Access Compliance Report Public Rights-of-Way (Curb Ramps)

Main Street: IRVINE_BLVD Cross Street: RED_HILL_AVE Location: NE

ADA ID: RPAT211027085403 Ramp Type: Type 1 - Perpendicular Diagonal Initial Pass/Fail: Fail Overall Compliance: No Severity Score: 2

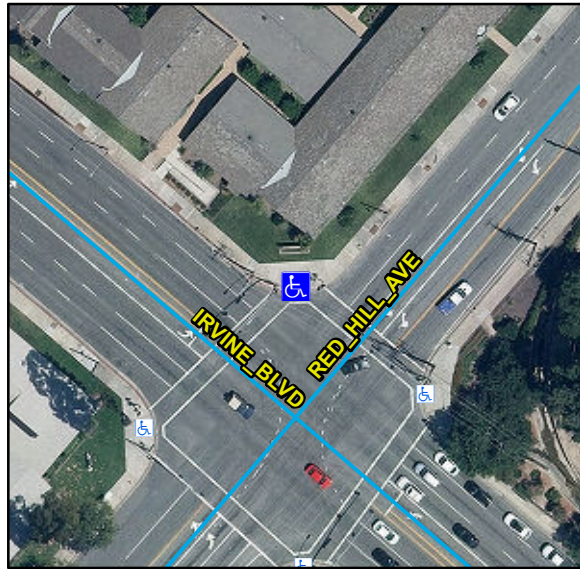
R204.3, R304.5.3, STD 1115

Remove & Replace Curb Ramp With Two New Directional Ramps or Equivalent.
